NORTH FALLS

Offshore Wind Farm

Draft Marine Mammal Mitigation Protocol (Clean)

Document Reference:	7.7
Volume:	7
Date:	December 2025
Revision:	5

Plate 1.2 Proposed piling mitigation procedures.

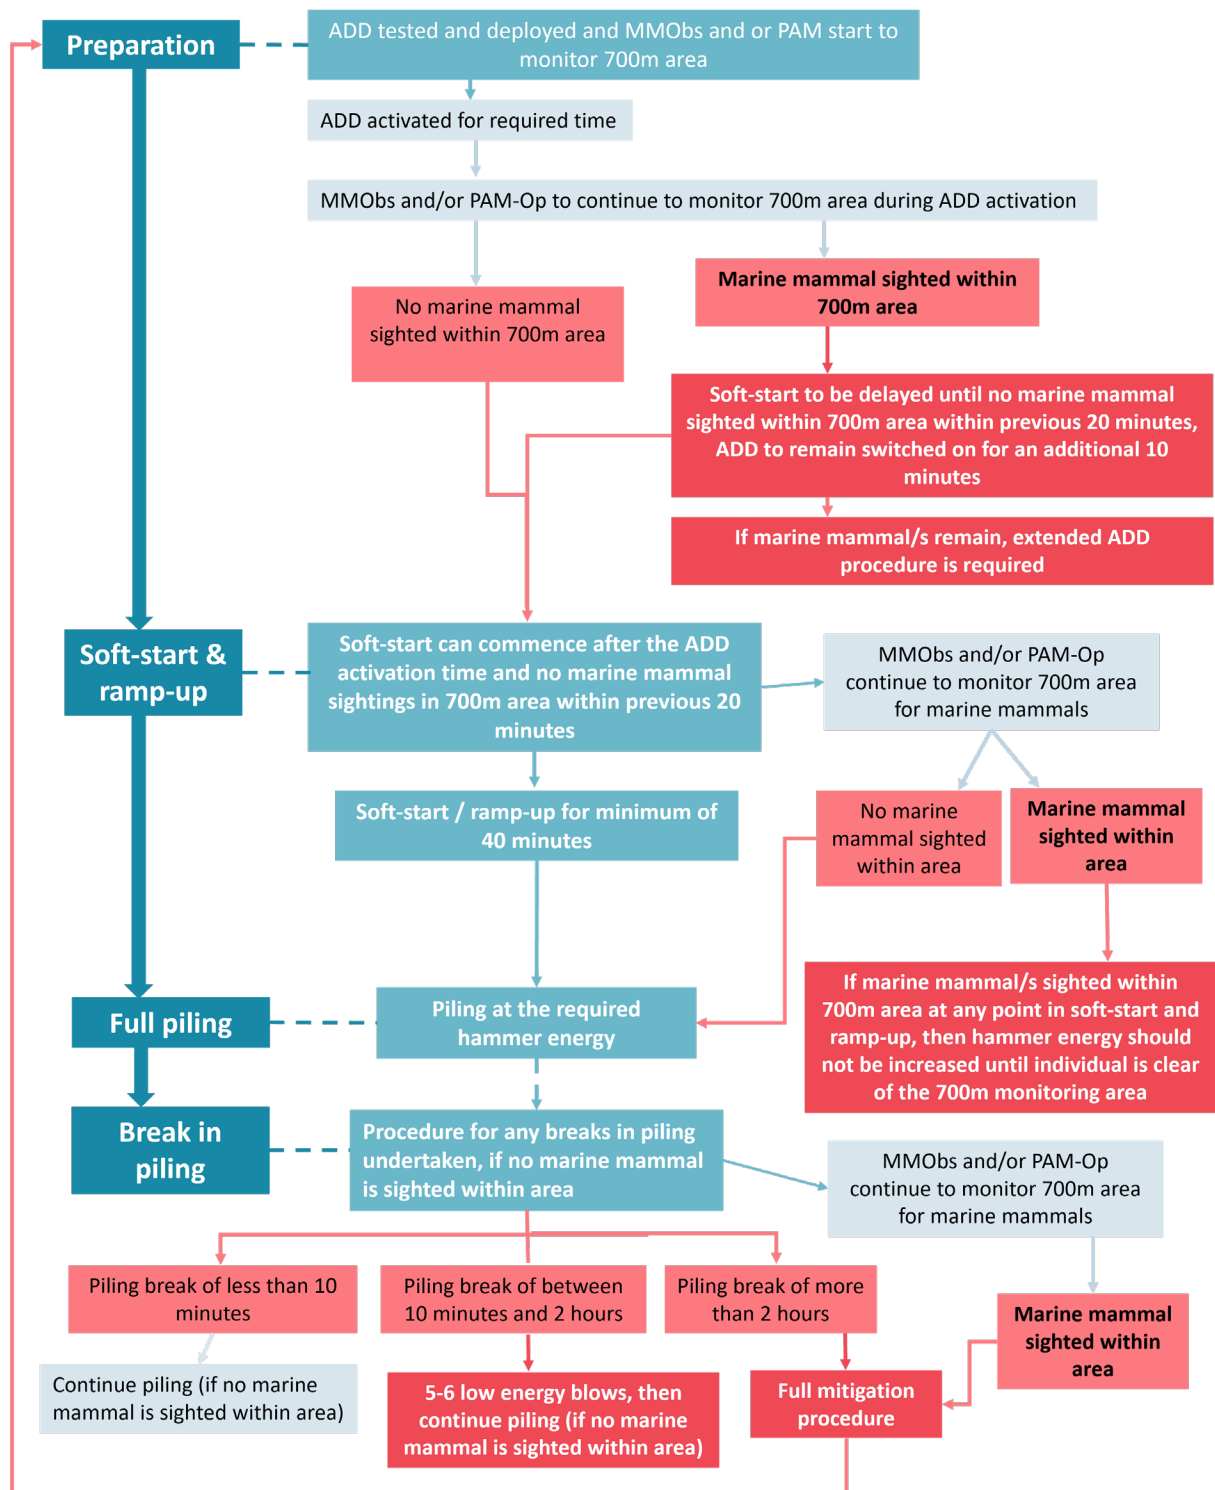
Natural England REP7-088	Table 1 _1	We are content with the amendments of the Plate 1.2 as per our advice.	Noted, no further action required.
Natural England REP7-088	Table 1 _2	Natural England notes that the Applicant has not accepted our advice on the use of Passive Acoustic Monitoring (PAM) for Unexploded Ordnance (UXO) clearance. The Marine Mammal Mitigation Protocol (MMMP) [REP6-030] still refers to this as 'unlikely to be required'. We also note the Applicant's response in E27 of Table 1.5 Examination Comments and Relevant Representations: "For UXO clearance the Applicant has committed to the use of PAM in instances when there are not favourable conditions with good visibility (sea state 3 or less)." Our advice remains that PAM is a required monitoring tool for UXO clearance especially given that the proposed development is	The Draft MMMP [Document 7.7, Rev 5] contains details for how PAM will be utilised, as set out in Section 1.4.3.2.2. As per Natural England's request the text has been amended to ensure PAM, if required, will be used in conjunction with the MMObs for the UXO clearance mitigation procedures.

Appendix B. Plots for Comparable Hammer Strike Energies

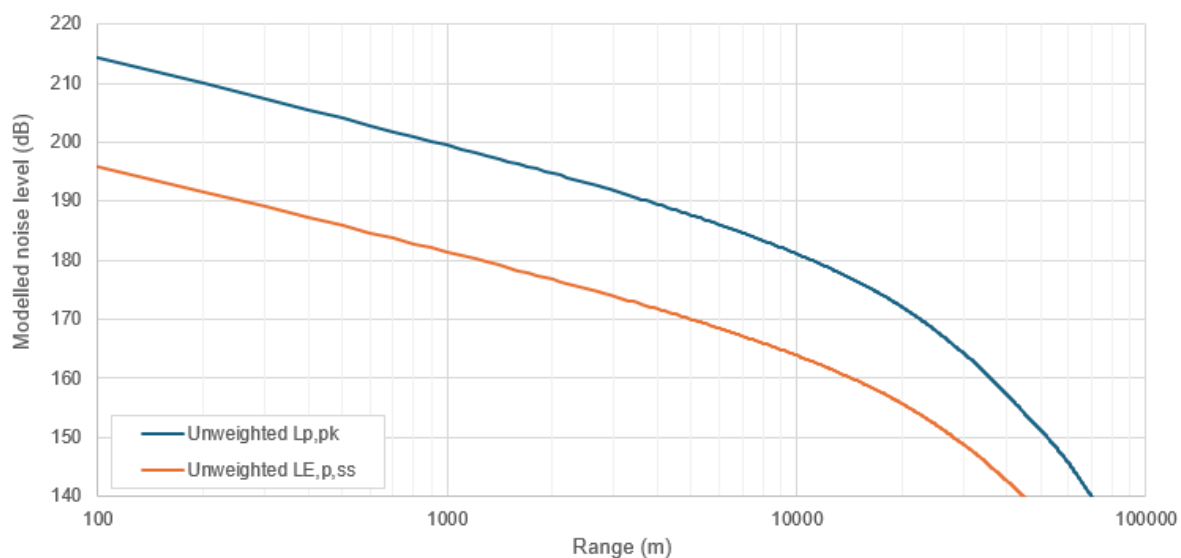
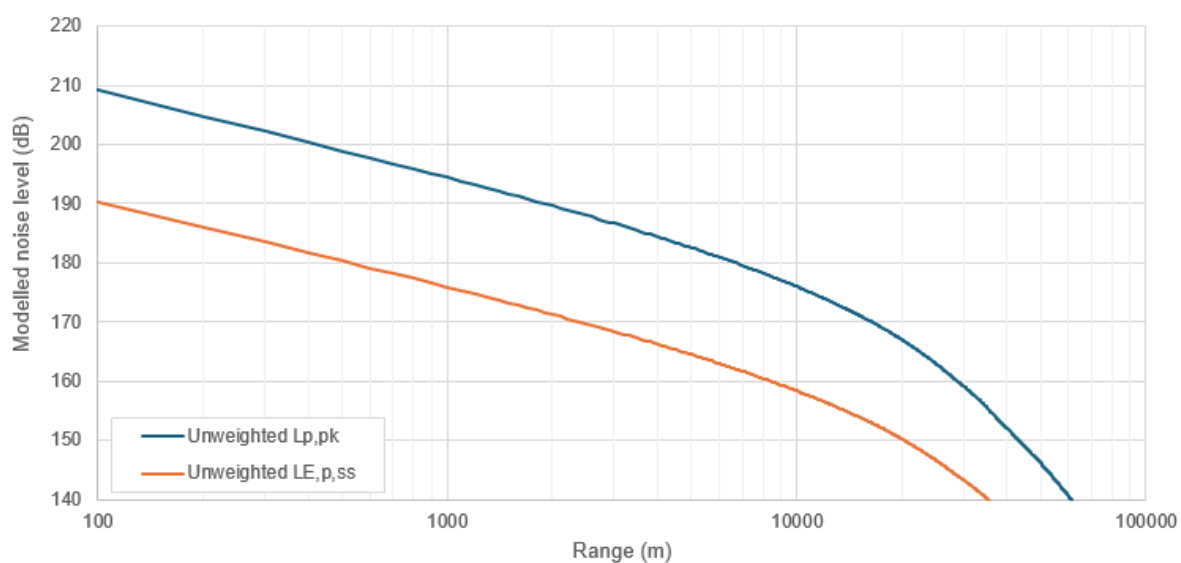
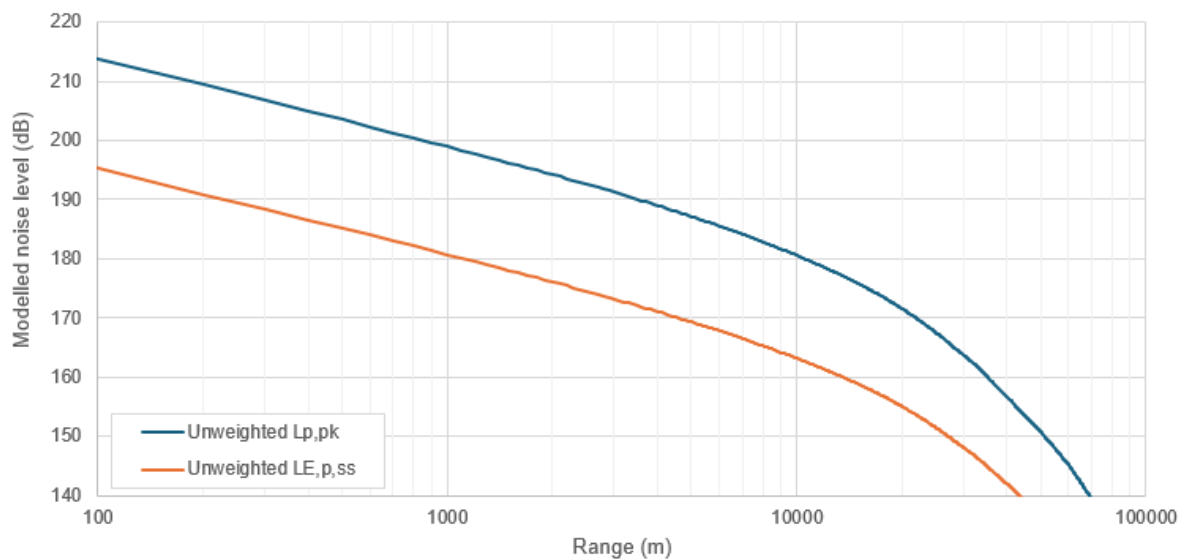
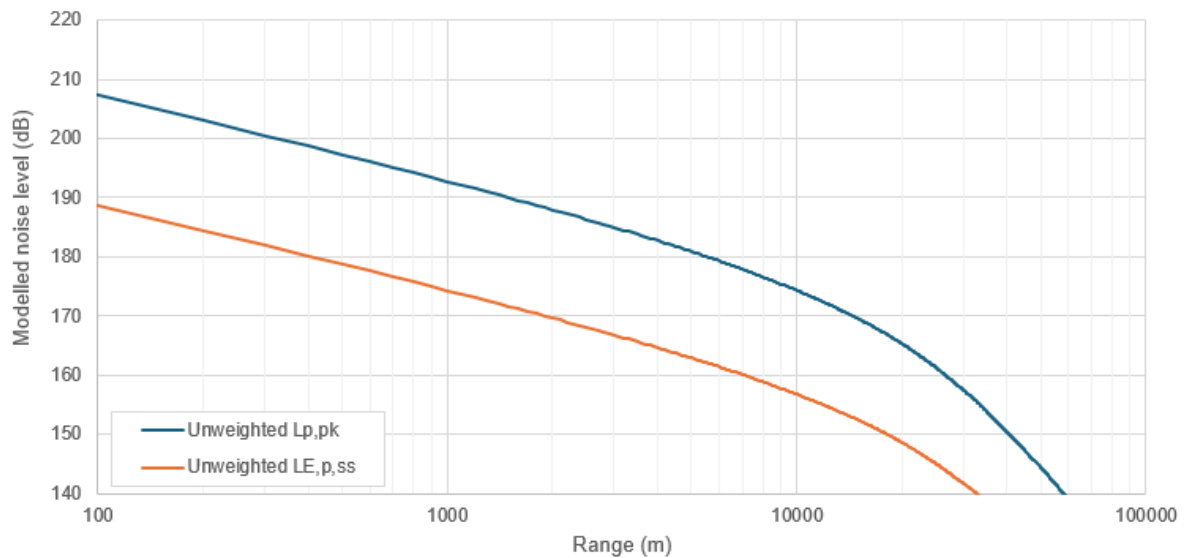
Consultee	Reference	Comment	Response / where addressed in the MMMP
		be required for a high-order clearance of a device of 120kg or higher.	
MMO	MMO-186	It is the understanding of the MMO that bubble curtains will be required for all high-order detonations, and this should be clear in the final MMMP. The MMO suggests that the Applicant consults with the specific UXO contractor to determine the appropriate parameters for safely deploying bubble curtains. If environmental conditions are not conducive to the use of a bubble curtain, then the MMO recommends postponing any high-order detonations until conditions are suitable.	As above in response to MMO-184.
MMO	MMO-195	The purpose of the noise monitoring during construction is to determine the actual underwater noise levels on site for comparison with the modelled levels presented in the ES. The MMO acknowledges that the measurements taken during installation will be constrained by various factors such as the piling plan and site limitations and a direct (like-for-like) comparison with a modelled scenario is unlikely to be possible. Nevertheless, even if the piling locations and choice of transects would not be matched precisely, both modelling and monitoring should provide enough information to deduce some envelope of received level curves in each case. Thus, some sort of comparison/s in the form of 'level vs range' plots (for comparable hammer strike energies), with the associated envelopes of variability, should be possible and would be expected. Therefore, the MMO recommends that such a plot is provided.	The Applicant has noted this comment from the MMO, therefore, these plots have been provided in Appendix B as part of the revised Draft MMMP (Revision 1).
